PINS Reference EN010137 Mona Offshore Wind Farm  
Interested Party numbers MNOW-S57019 & MNOW-S57018

### **POST HEARING SUBMISSION ISSUE SPECIFIC HEARING 6**

The position of the water pipe is shown below as provided by Dŵr Cymru.

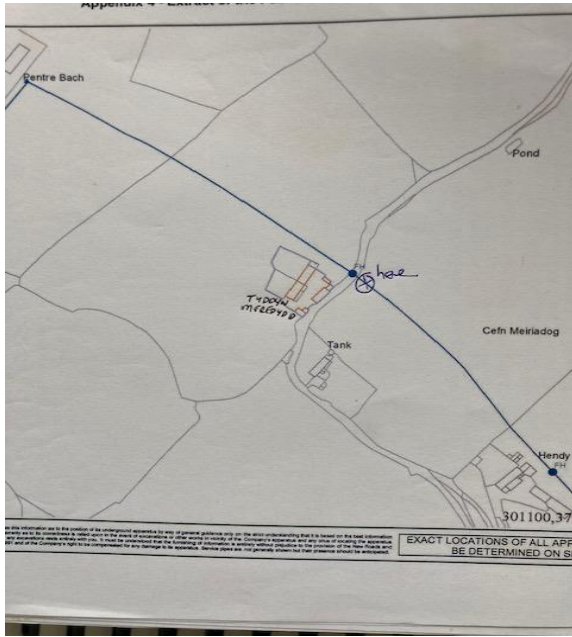
In the noise modelling predictions, impacts from Joint bay activity for Tyddyn Meredydd were classified as Medium Impact but then downgraded to Low by the applicant, citing that it would be trenchless cabling due to a mains water pipe and so unlikely that any joint bays would be undertaken behind Tyddyn Meredydd.

It is likely that the trenchless cabling under the water main just below/ behind our property will only be a relatively short length, and since the water main is approximately 50mts away from the South Western edge of our boundary then it does not appear ( if the detailed electrical design for the cable route has not been established) ,to state at this time that no Joint bays will be in close proximity to Tyddyn Meredydd .In simple terms the statements made in the noise modelling assessment and the information presented at ISH6 appear inconsistent.
